CS Memorandum No. 1400

CMB Meeting Minutes #117

REFERENCE Project No. M544.1, Contract No. 149 Task 1-8.02
Final Design

SUBJECT: Configuration Management Board Meeting # 117 – Rev. No. 0

EXHIBIT A
12/28/2012

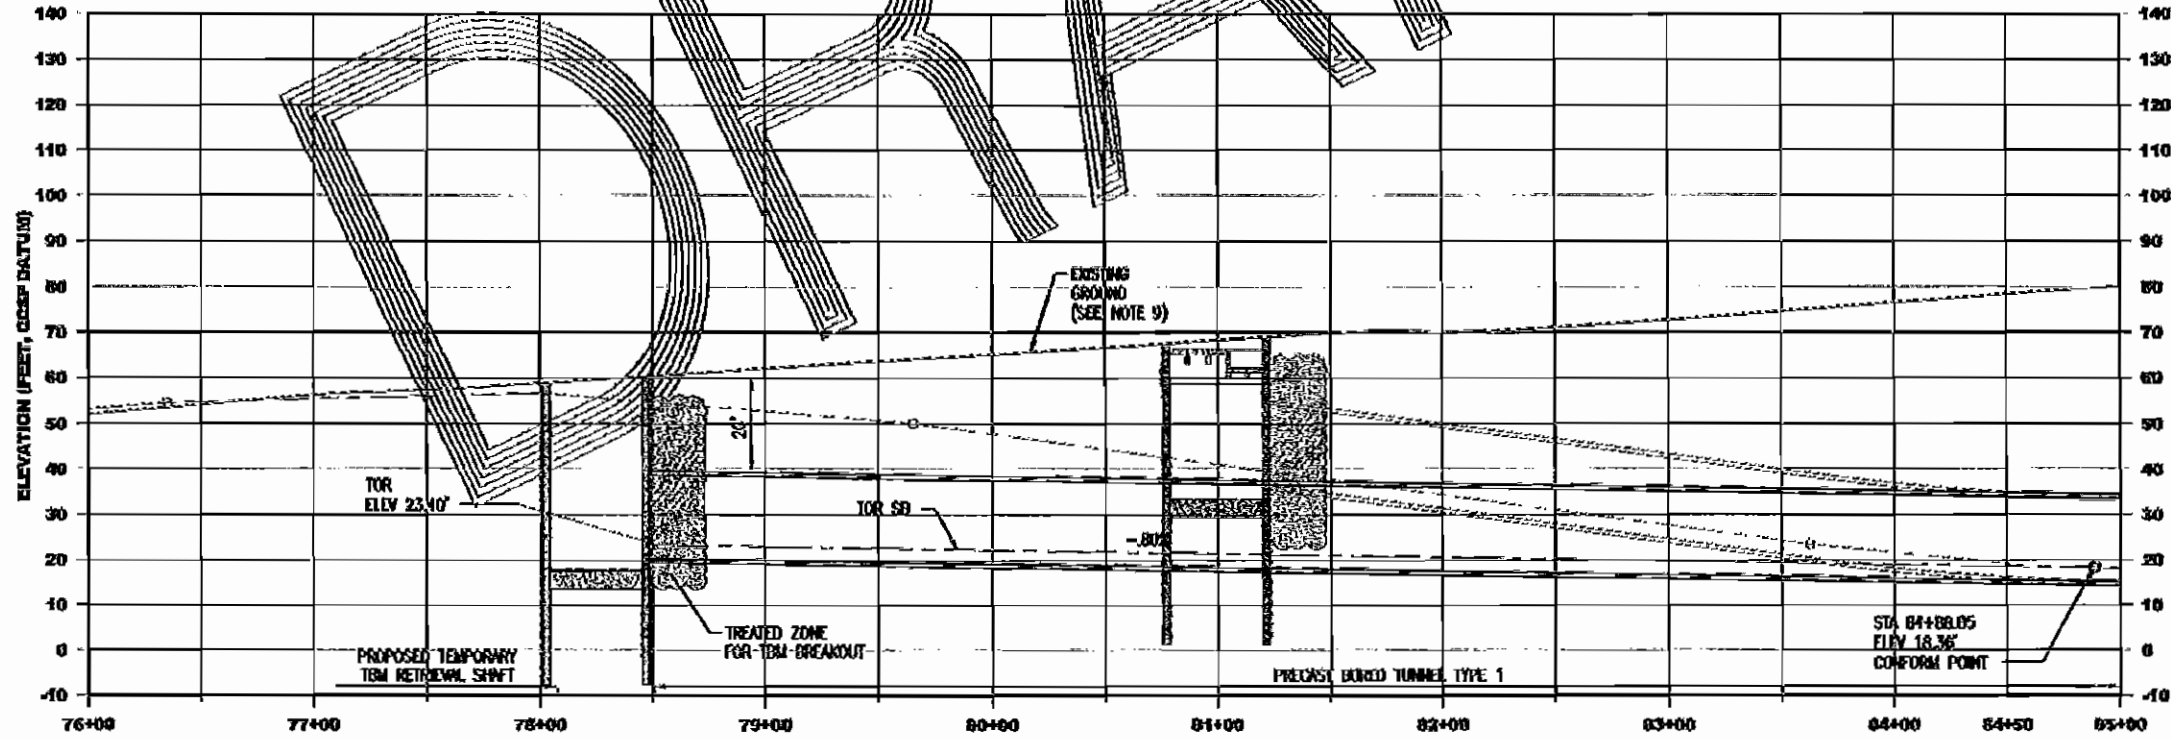
- Design and demolish existing building at 1731-1741 Powell Street. Demolition to include entire building; roof trusses and perimeter walls are not to be retained as shown in attached representative Demolition Plans.

- Design and Construct a reinforced concrete bulkhead in each tunnel at Property Line, Public ROW side.
- Design and Construct settlement mitigation measures based on existing Contract 1252 criteria. Settlement mitigation to include settlement monitoring plan compliant with existing Contract 1252 scope and function.
